Preliminary Consultation
MONTGOMERY COUNTY HISTORIC PRESERVATION COMMISSION
STAFF REPORT

Address:	6100 Connecticut Avenue, Chevy Chase	Meeting Date:	3/22/2023
Resource:	Outstanding Resource Chevy Chase Village Historic District	Report Date:	3/15/2023
Applicant:	Chevy Chase Country Club (DLR Group & EHT Traceries)	Public Notice:	3/8/2023
Review:	Preliminary Consultation	Tax Credit:	N/A
		Staff:	John Liebertz

PROPOSAL: Chevy Chase Club fenestration alterations, construction of new terrace, hardscape and pathway alterations, terrace alterations, installation of cable railings, new rooftop mechanical equipment, tree removal, and lighting alterations.

New Construction – South Terrace and Deck

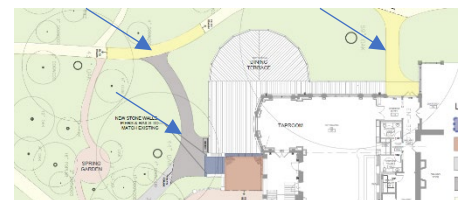
The applicant proposes: 1) the partial demolition of the western section of the existing brick patio and stair; 2) a new brick patio that adjoins the existing brick patio with the proposed deck; 3) new stone stair with stone walls, piers, and railings that access the new brick patio; and 4) construction of a new wood deck that wraps the west and south elevations of the 1958 addition.

The proposed design, scale, and materials of the proposed terrace and deck is compatible with the historic resource. The submission continues the design and feel of the original clubhouse with its matching ornate Chippendale railing that has been retained or included in various iterations of the rear elevation over the last 100 years. The inclusion of cable rails (behind the wood railing and required per code) will not adversely affect the overall design of the clubhouse. While the terrace necessitates the removal of a 10” sweetgum tree, there are no noted impacts to the nearby 59-inch Oak tree. All these alterations should be approved as a matter of course as they are on the rear elevation and do not affect the overall scale and massing of the building. The tree removal should be included in the final HAWP application.

Staff recommends that the HAWP application provide details and specifications for all elements. Information absent from the preliminary application includes: 1) details regarding proposed footers or structural supports for the proposed deck, how these supports will impact the surrounding trees (of particular interest the 59-inch oak tree), and any tree protection plans that will be implemented; and 2) specifications and detailed drawings for the stone stair accessing the brick patio.

PROPOSED OVERALL PLAN 2ND FLOOR PLAN

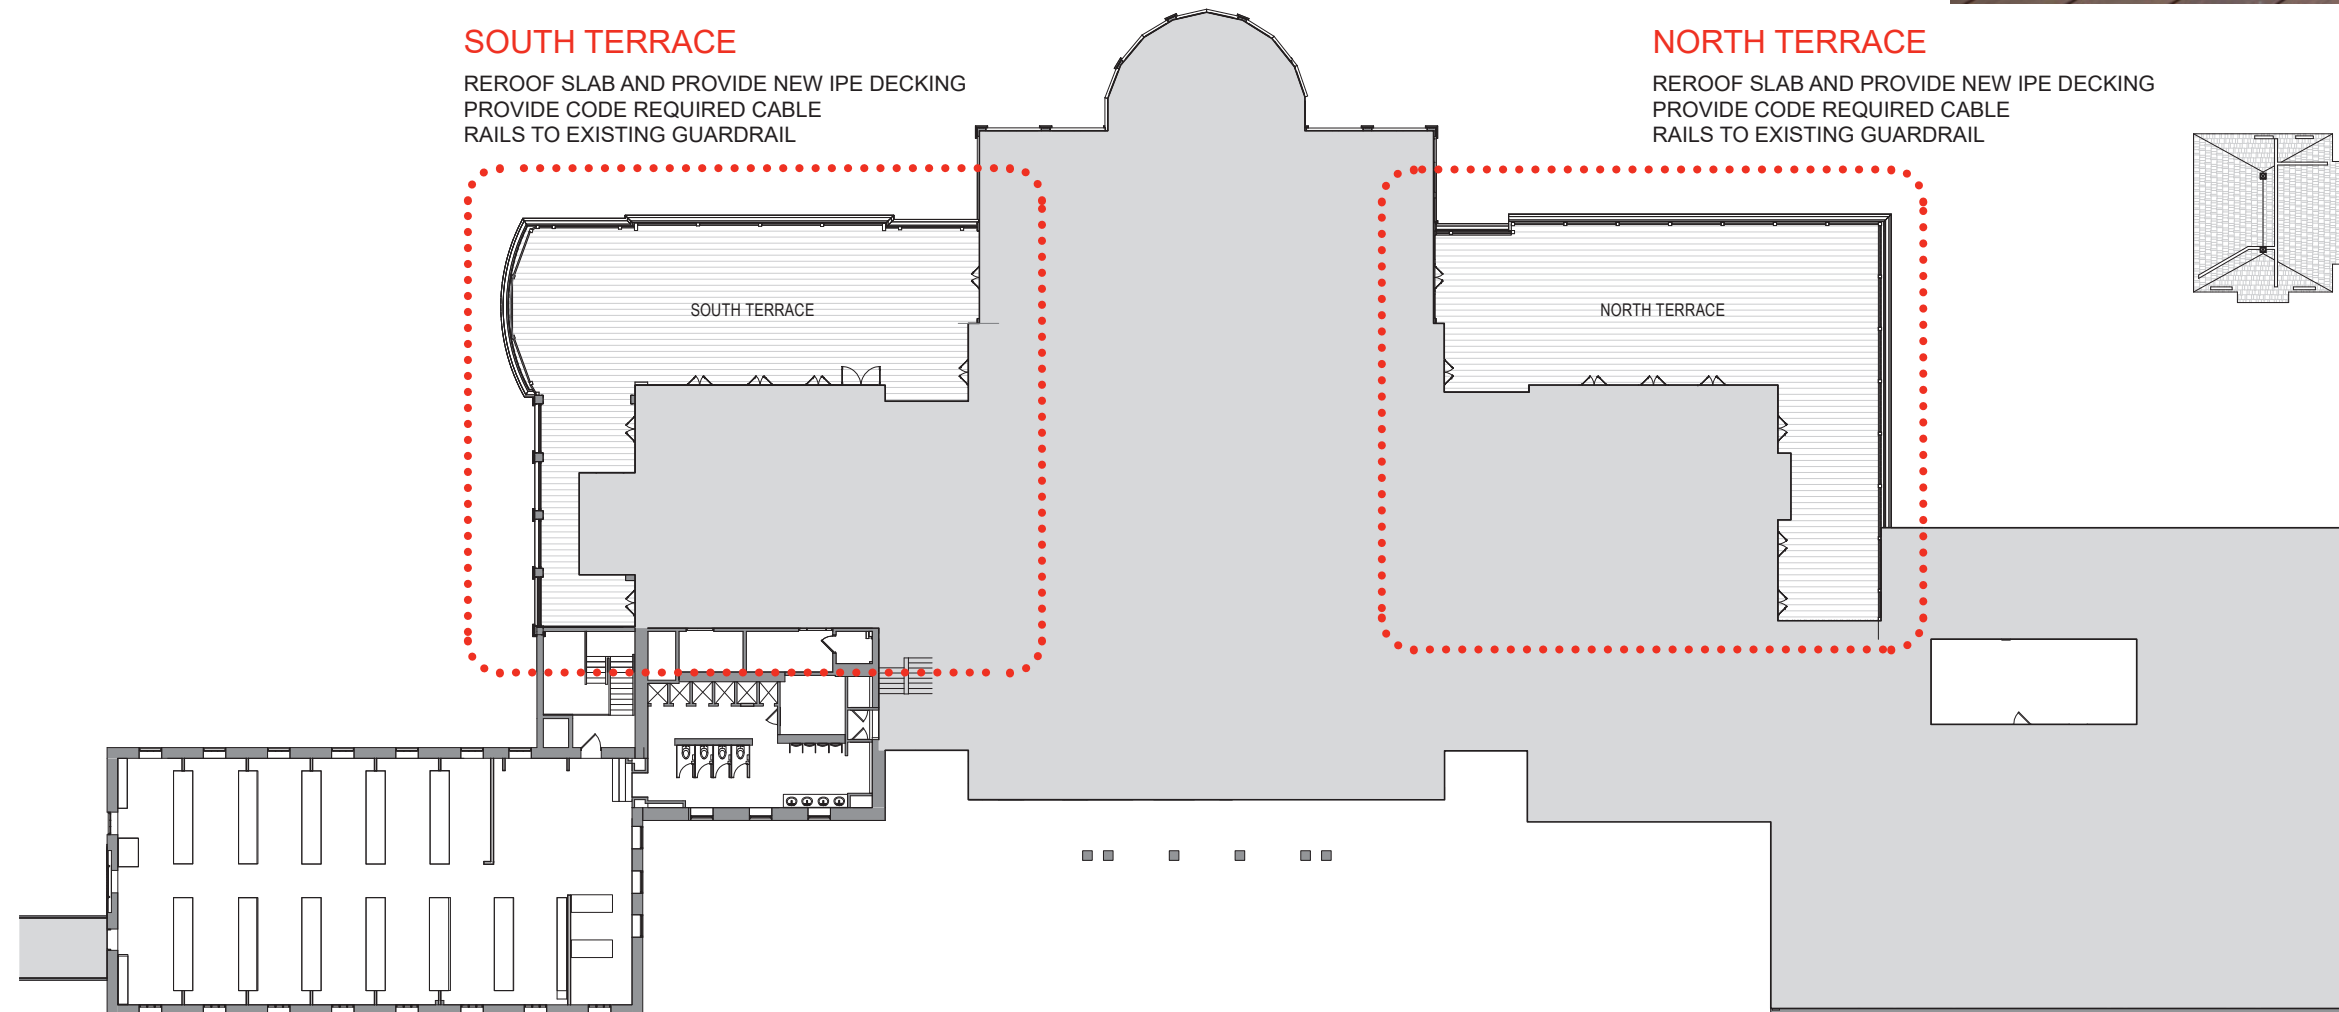
The applicant proposes to: 1) reroof the existing north and south roof terraces and install wood decking; and 2) install a cable rail behind the character defining Chippendale wood railing as required by code. The wood decking would not be visible from any point of view other than standing on the roof terrace. The installation of the cable railing has less adverse effect than other potential treatments to the historic railing (such as increasing its height) and would be rather transparent as shown in examples provided by the applicant. Staff recommends that the HAWP application provide details and specifications for all elements and that the proposed changes are approved as a matter of course as it is on the rear elevation.

PROPOSED OVERALL PLAN ROOF - FLOOR PLAN

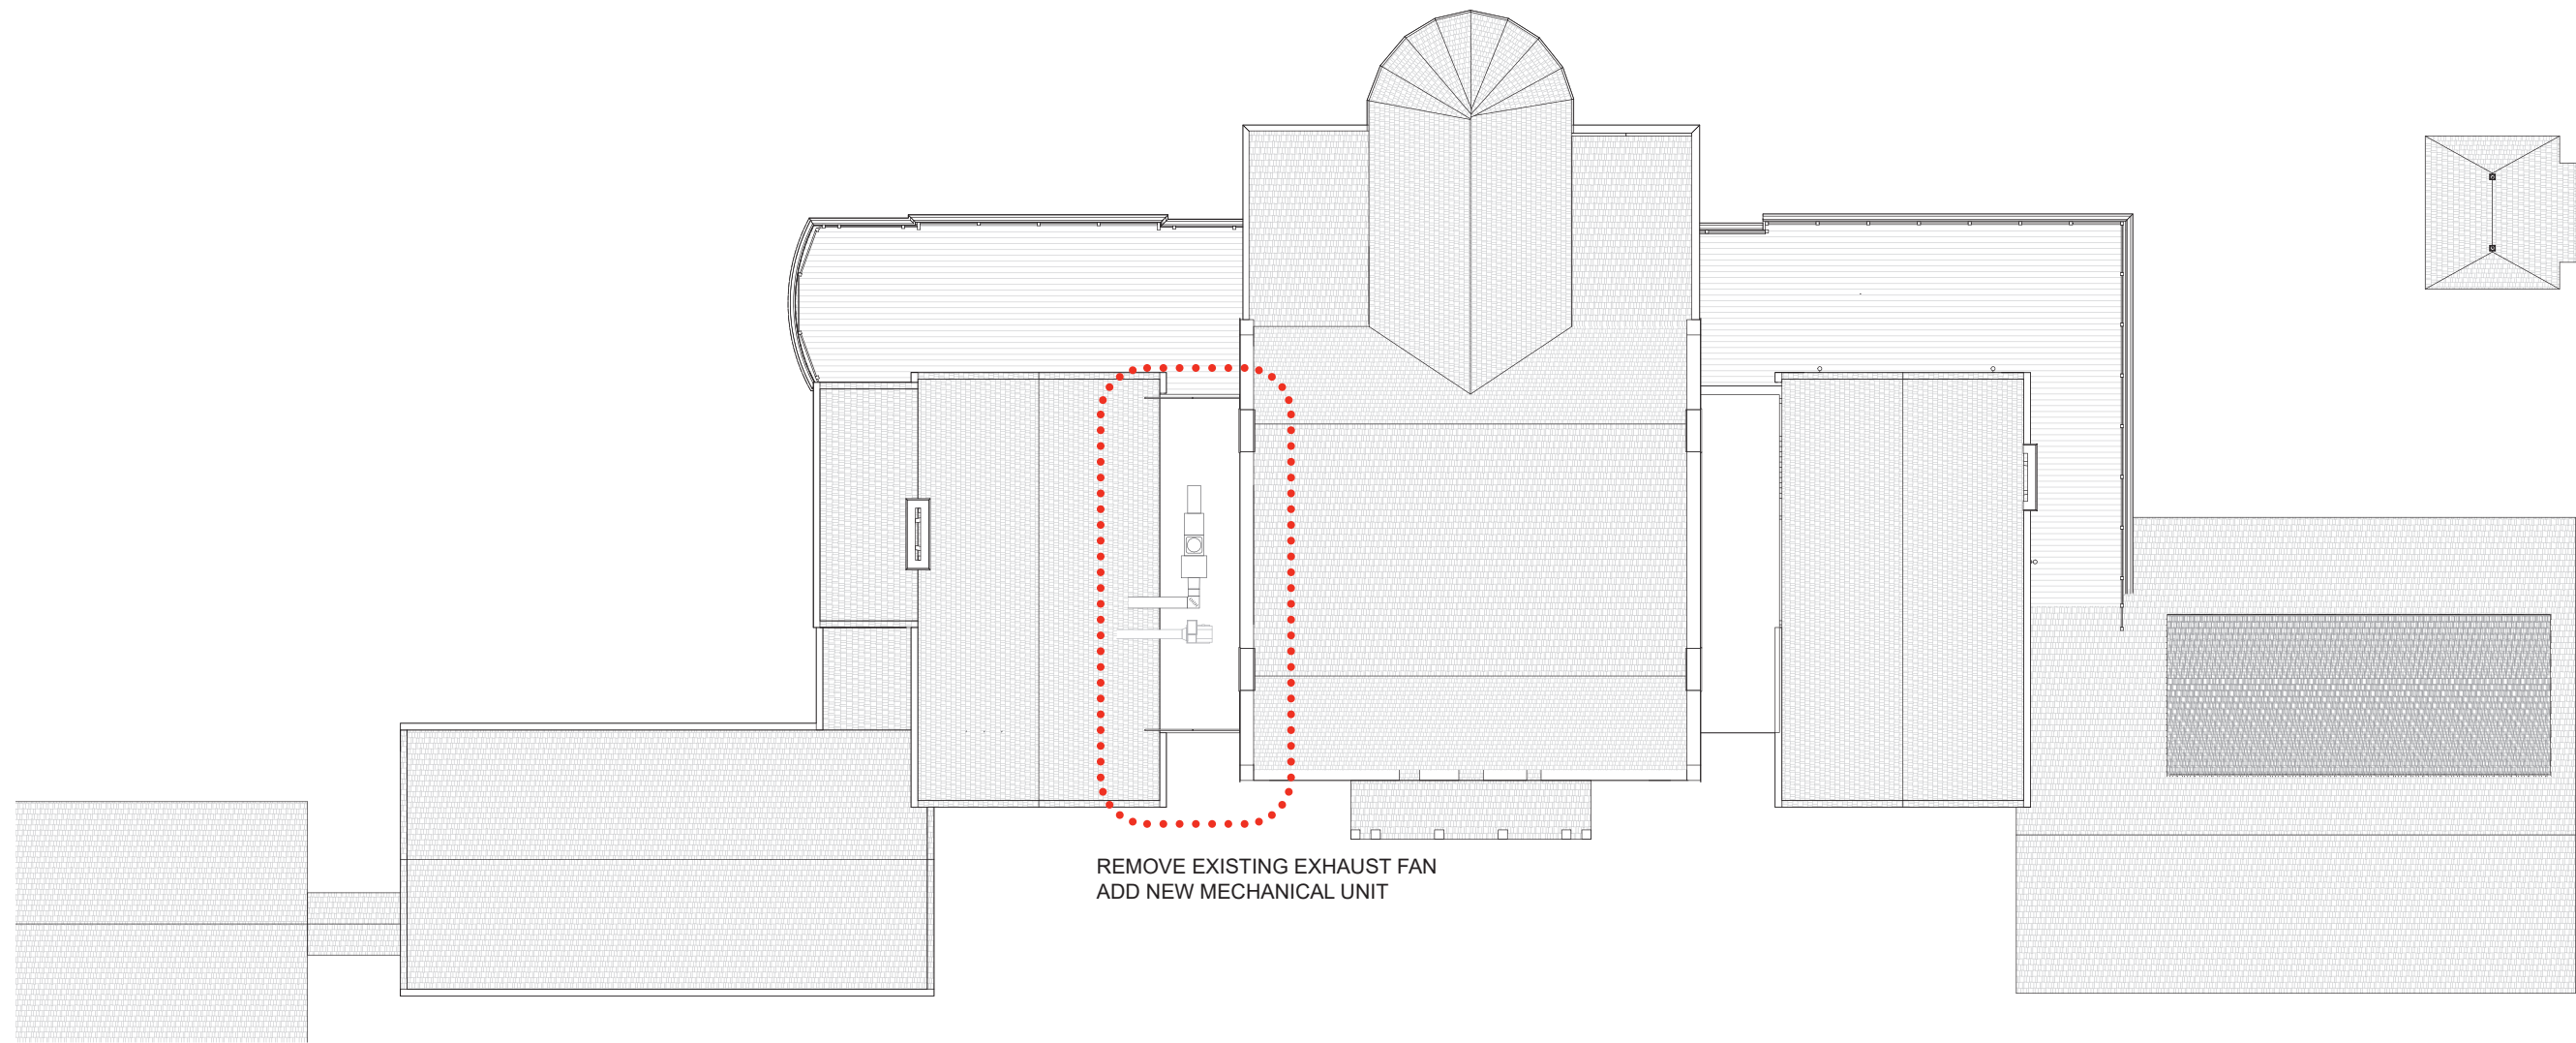
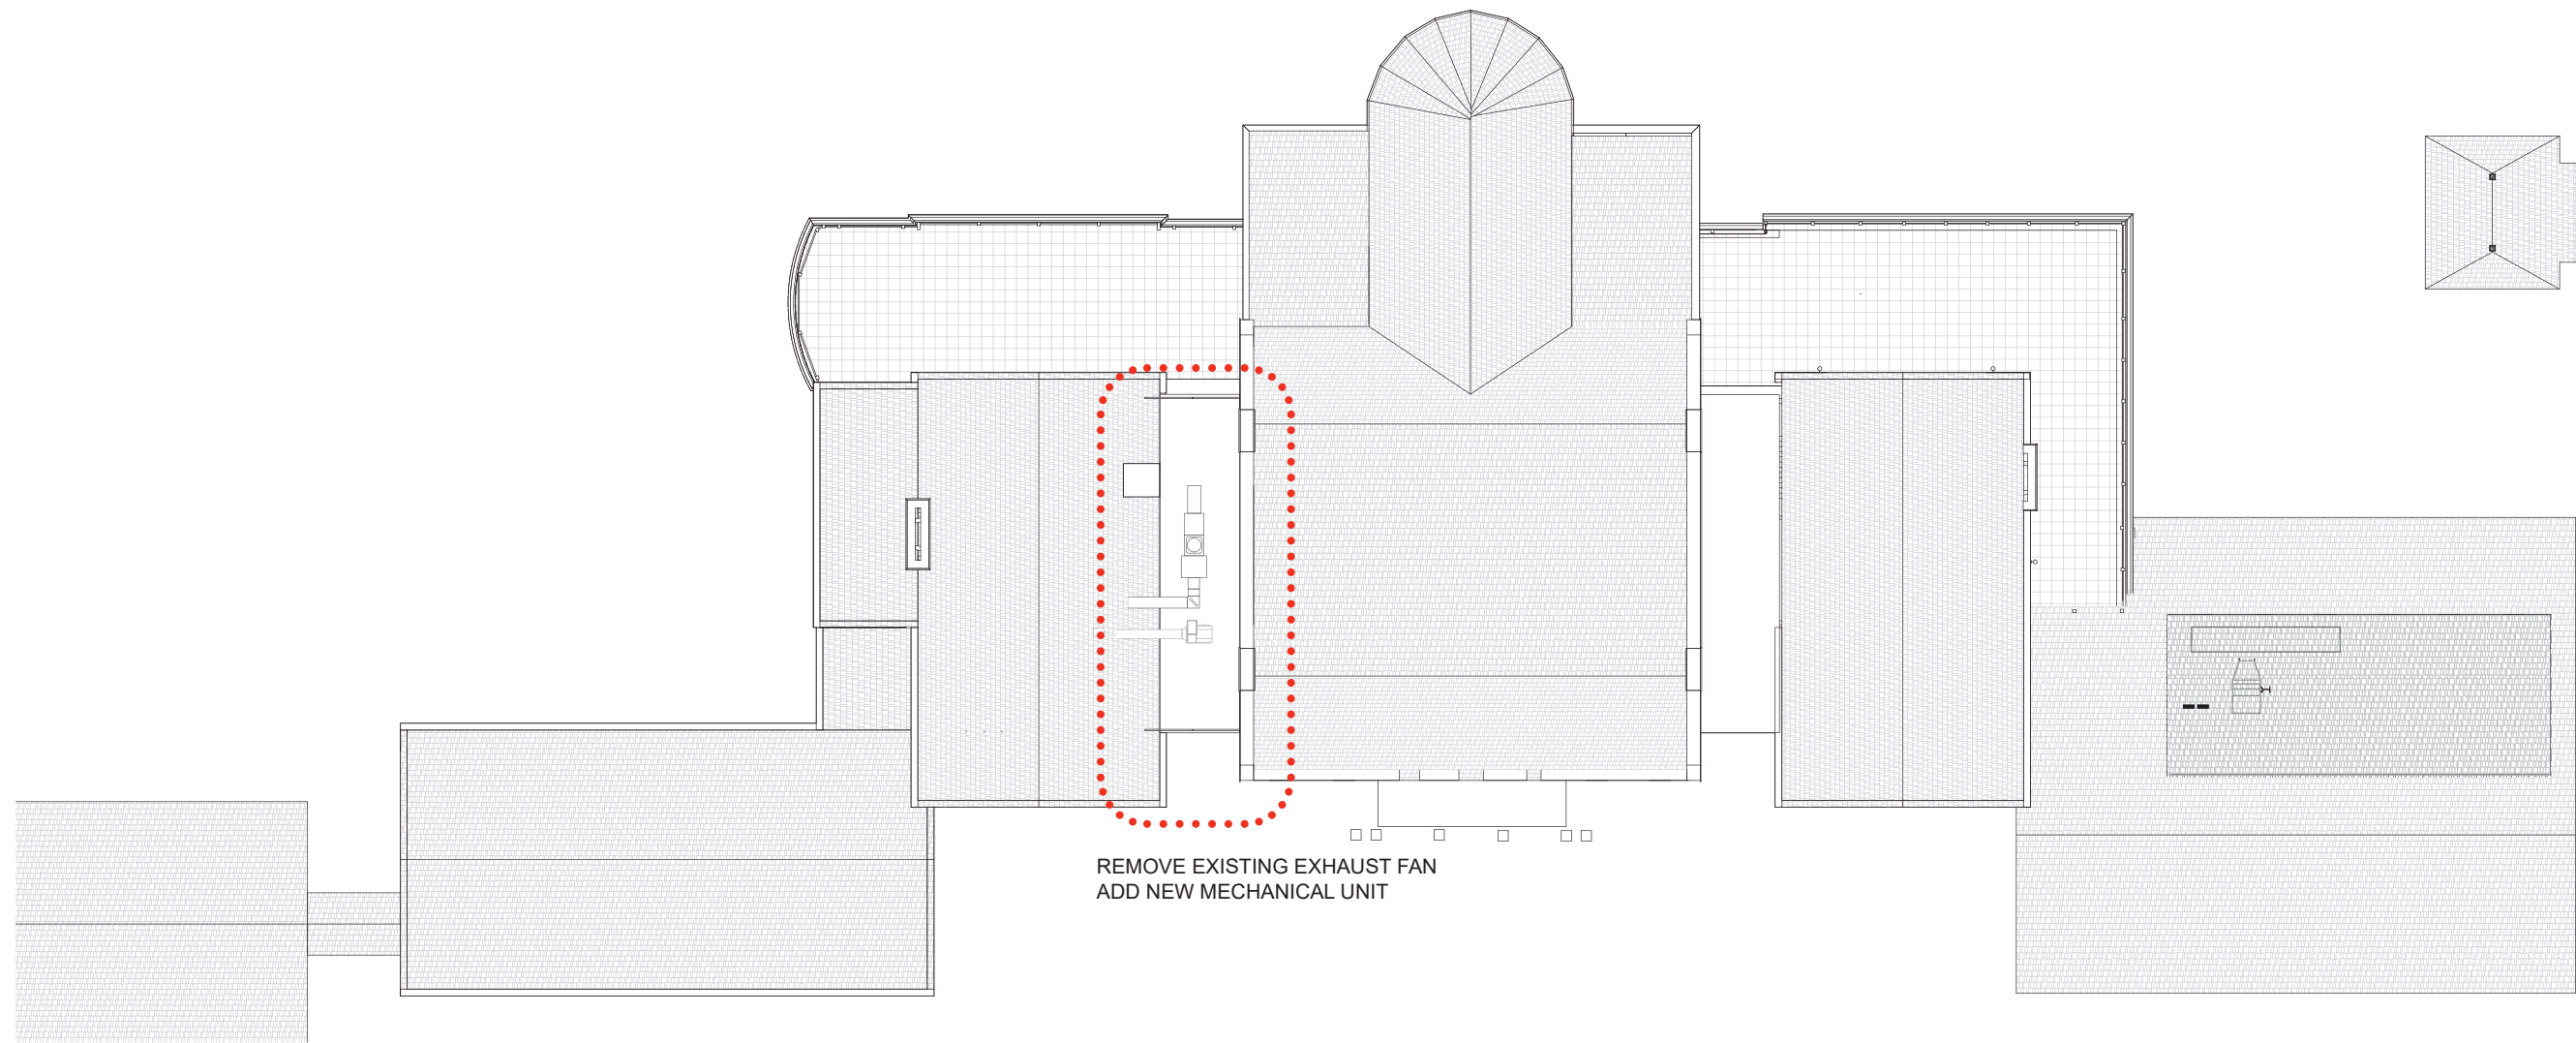
The applicant proposes to remove an existing exhaust fan from the roof and install new mechanical equipment. As shown in the preliminary submission, the mechanical equipment will not be visible when looking east from Connecticut Avenue or west from the club’s property. Staff recommends that the HAWP includes details and specifications for all equipment and that it be approved as a matter of course due to its lack of visibility.

WEST ELEVATION WINDOW REPLACEMENT

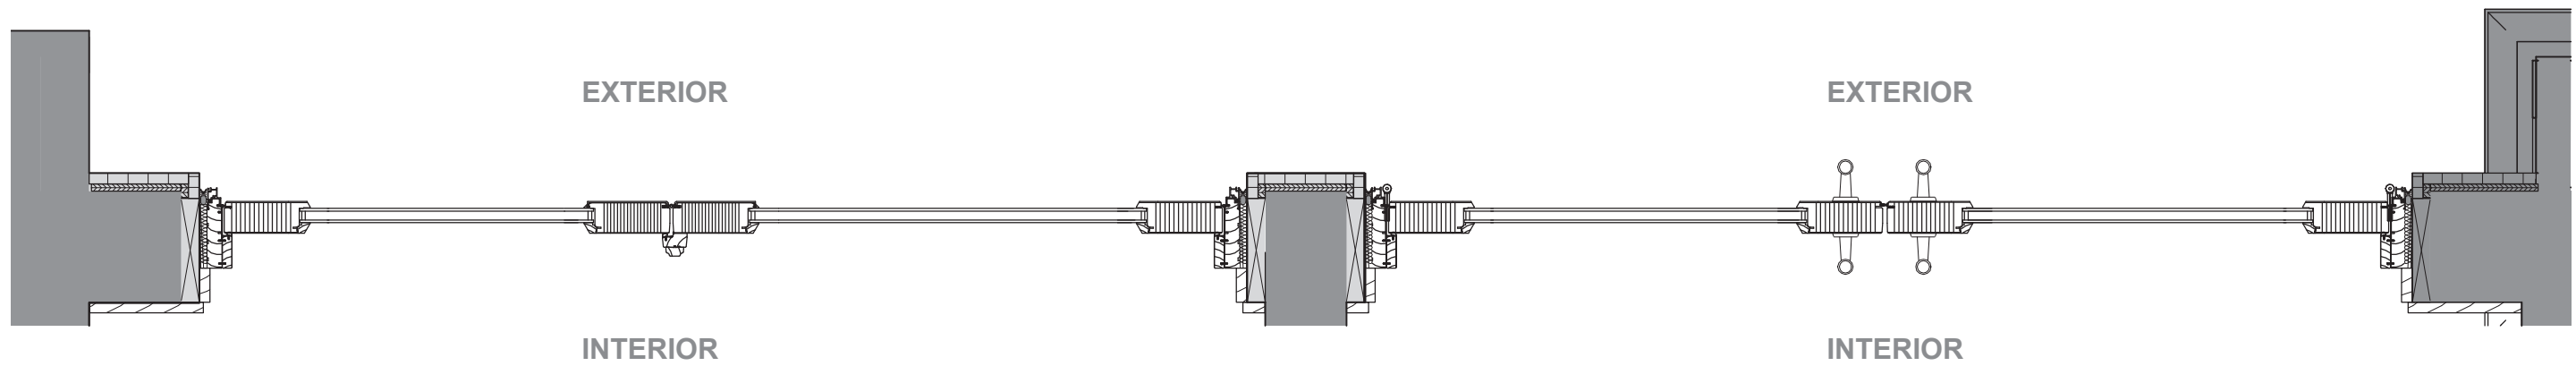
The applicant proposes the in-kind replacement of the existing fixed wood windows on the 1958 addition. In addition, the applicant proposes to replace six single-light, triple-hung, wood windows on the west and south elevations with two-light fixed windows. The proposed window muntin would align with and continue the horizontal line created by the muntins of the existing fixed windows. The windows are compatible with the design and fenestration patterns of the clubhouse and should be approved as a matter of course as they are located on the rear elevation of the building. Future HAWP applications should include all specification sheets and affirm that the windows are constructed of wood.
